MIL "ON" DTC P219A or P219B

YEAR(S)	MODEL(S)	ADDITIONAL INFORMATION
2012	RX350

Some 2012 model year RX 350 vehicles may exhibit a MIL "ON" condition with DTC P219A or P219B present. The Engine Control Module/ECM (SAE term: Powertrain Control Module/PCM) logic has been modified to reduce the possibility of this condition occurring. Please follow the repair procedure below to address this condition.

Figure 1. Location of Authorized Modifications Label on 2012 RX 350

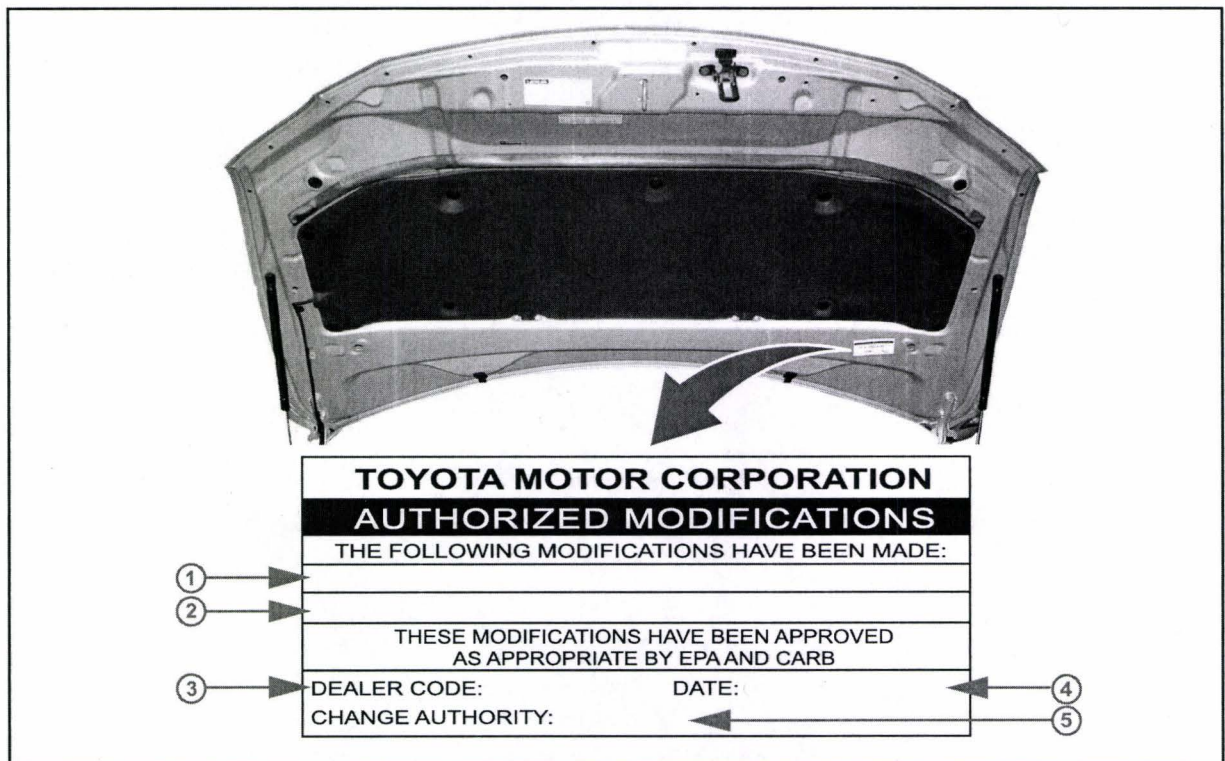
2. Check for the Authorized Modifications Label affixed to the vehicle in the location shown in Figure 1. Confirm if the ECM (PCM) calibration has been updated. If the calibration ID listed is NOT the latest ECM (PCM) calibration — go to step 3.

A. Using a permanent marker, enter the following information on the label:

- ECM part number [Refer to the **Parts Information** section for the **CURRENT PART NUMBER**]
- Calibration ID(s) [Refer to the **Calibration Identification Chart** for the **NEW CALIBRATION ID**]
- Dealer Code
- Repair Date
- Change Authority [**This bulletin number**]

B. Affix the Authorized Modifications Label to the vehicle at the location shown in Figure 1. The Authorized Modifications Label is available through the MDC, P/N 00451-00001-LBL.
